T10/04-378r1 SAS-1.1 Clarification of SATA Signaling Level Specification

To: T10 Technical Committee
From: Barry Olawsky, HP (barry.olawsky@hp.com)
Date: 17 January 2005
Subject: T10/04-378r1 SAS-1.1 Clarification of SATA Signaling Level Specification

Evaluate validity of SATA mode receiver sensitivity spec for XR and IR.

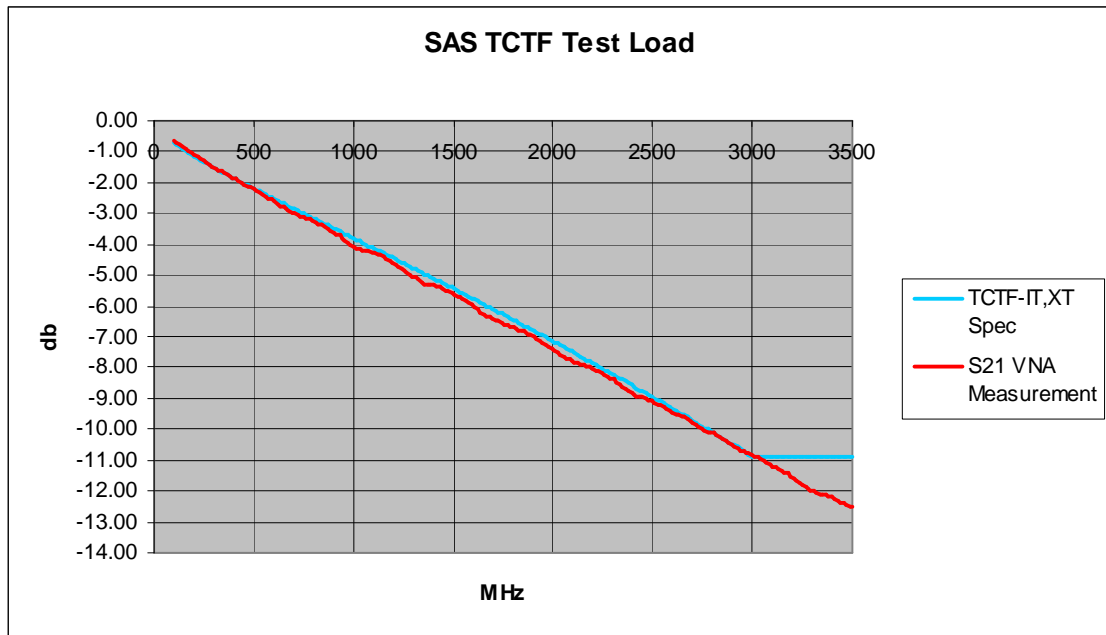
Add following note to table 30 referencing the 225mV cell in SATA column.

Amplitude measurement methodologies of Serial ATA and this standard differ. Under conditions of maximum rise/fall time and jitter, eye diagram methodologies may indicate far less amplitude than the technique specified by the Serial ATA standard. To compensate for this difference, it is recommended that Serial ATA devices used in SAS applications undergo additional testing. Eye-diagram tests should be used to confirm the minimum SATA device amplitude specified in the Serial ATA specification.
